# Mobile Intel® Pentium® 4 Processor-M

Specification Update

*November 2003*

Document Number: 250721-020

**Figure 13. System Bus Reset and Configuration Timings**

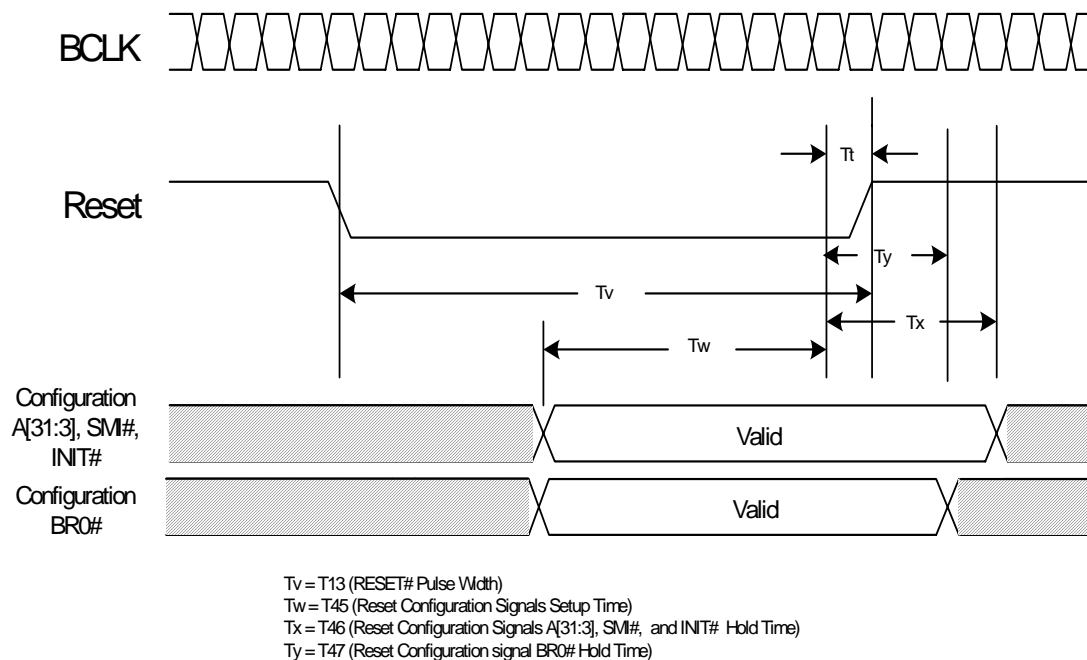
## T2. BR0# Maximum Hold Time Specification Change

The BR0# maximum hold time has changed to 2 BCLKs. This change will be shown in the “System Bus AC Specifications (Reset Conditions)” table and “System Bus Reset and Configuration Timings” figure of the *Mobile Intel® Pentium® 4 Processor - M Datasheet*. This change will be incorporated in the next revision of the datasheet.

The following figure will be modified to reflect this change:

T# Parameter	Min	Max	Unit	Figure	Notes
T45: Reset Configuration Signals (A[31:3]#, BR0# INIT#, SMI#) Setup Time	4		BCLKs	13	1
T46: Reset Configuration Signals (A[31:3]#, INIT#, SMI#) Hold Time	2	20	BCLKs	13	2
T47: Reset Configuration Signal BR0# Hold Time	2	2	BCLKs	13	2

1. Before the deassertion of RESET#.
2. After clock that deasserts RESET#.
